VIRGINIA ELECTRIC AND POWER COMPANY (DOMINION)
NORTH ANNA POWER STATION UNITS 1 AND 2
RESPONSE TO NRC AUDIT
REGARDING LICENSE AMENDMENT REQUEST TO ADDRESS THE ISSUES
IDENTIFIED IN WESTINGHOUSE DOCUMENTS NSAL-09-5, REV. 1 AND NSAL-15-1

**Additional Information in Support of NRC Review of License Amendment Request
Associated with Westinghouse NSALs-09-5, Rev. 1 and 15-1, Rev. 0**

**Virginia Electric and Power Company
(Dominion)
North Anna Power Station Units 1 and 2**

Sample Application of an Operating Space Reduction

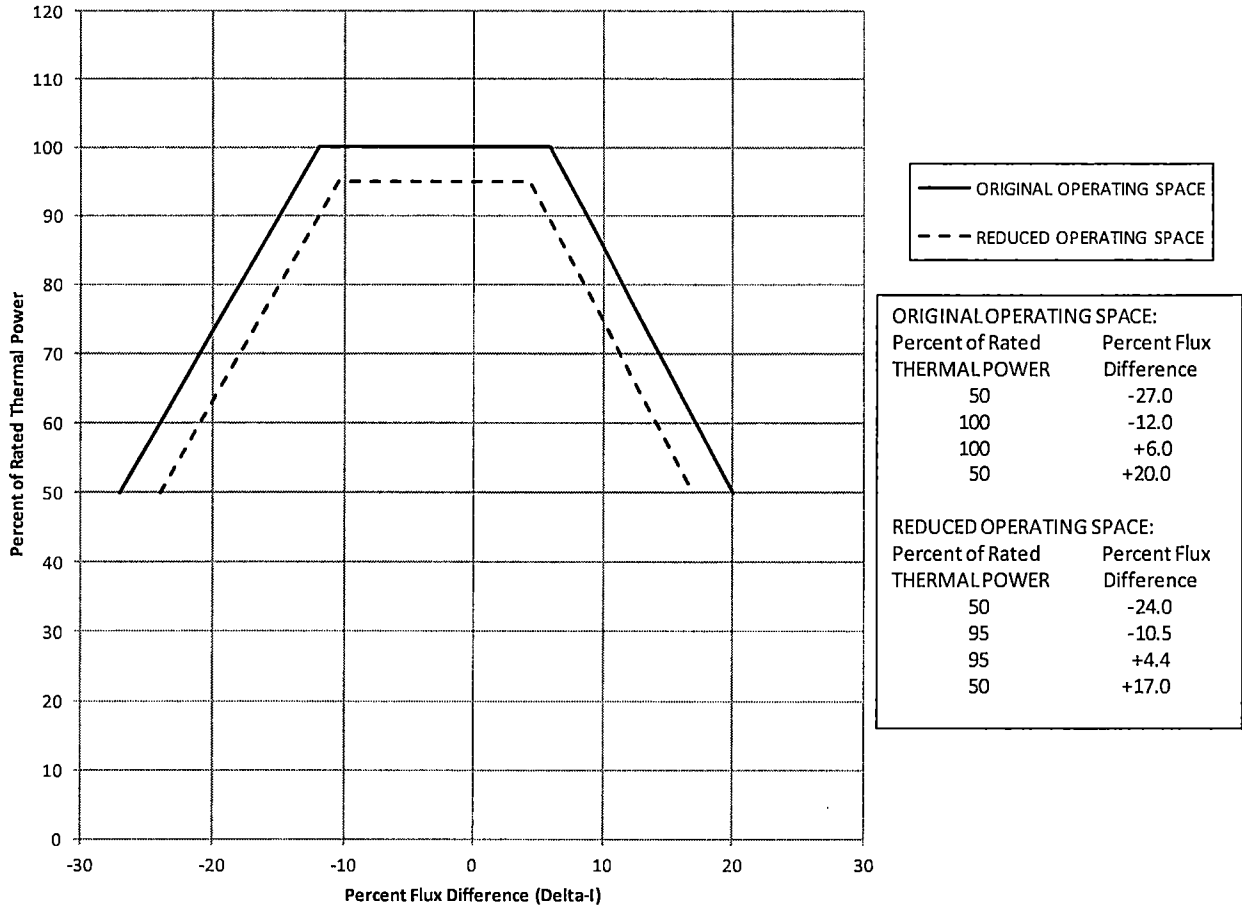
Regarding LCO 3.2.1, why are the proposed Required Actions B.3 and B.4 indicated to reduce the associated setpoints (Neutron Flux and Overpower delta-T, respectively) for each 1%, 'that THERMAL POWER is limited below RTP by Required Action B.2'?

During review of this question it was identified that further clarification may be needed regarding AFD limit and THERMAL POWER reductions imposed by Required Actions 3.2.1.B.1 and 3.2.1.B.2, respectively. The AFD band and THERMAL POWER reductions are designed to limit the operating space in which the unit can operate to maintain margin for $F_Q^T(Z)$. Application of the power reduction is meant to limit the maximum THERMAL POWER at which the unit can operate (less than RTP). Likewise, application of the AFD limit reductions are meant to narrow the AFD limits from what is specified in the COLR. Therefore, a modified version of the proposed COLR Table 3.2-3 (Attachment 1 of Reference 1) is provided to more clearly define the Required Actions. An example application of the operating space reductions is presented after proposed COLR Table 3.2-3.

LCO 3.2.1.A currently requires either a 1% reduction of power or a 1% reduction in AFD limits for each 1% by which F_Q^M(Z) exceeds its limit (referred to as "1-for-1" below). The Dominion analysis performed during the review of NSAL-09-5, Rev. 1 (Reference 11) determined that a combination of reductions in power and AFD limits were necessary to regain the required margins to satisfy the LCO for transient FQs. The power reductions required can be greater than the "1-for-1" Required Actions of the current LCO. Since "1-for-1" required actions may no longer be adequate for restoring margin, requiring "1-for-1" trip setpoint reductions may also be inadequate. Therefore, the proposed language for Required Actions B.3 and B.4 requires identical reductions in trip setpoints as those identified in Required Action B.2 to restore F_Q margins. In the event that F_Q^T(Z) does not meet its limit, LCO 3.2.1.B Required Actions are performed to reduce the allowable operating space. Required Actions B.3 and B.4 ensure that the neutron flux high trip setpoints and overpower delta-T trip setpoints are reduced by at least the amount that THERMAL POWER is limited below RTP by Required Action B.2.

- 1) The results of a flux map analysis show that $F_Q^T(Z)$ exceeds the limit by 1.5%.
- 2) THERMAL POWER is limited to ≤ 95% RTP. If current THERMAL POWER > 95%, reduce power to ≤ 95% RTP.
- 3) Negative and Positive AFD bands from COLR Figure 3.2-2 are narrowed by ≥ 3.0%. Adjust AFD as necessary to adhere to the limitation in Table 3.2-3.
- 4) The figure below illustrates: a) the original operating space and b) the reduced operating space needed to improve margin for $F_Q^T(Z)$.
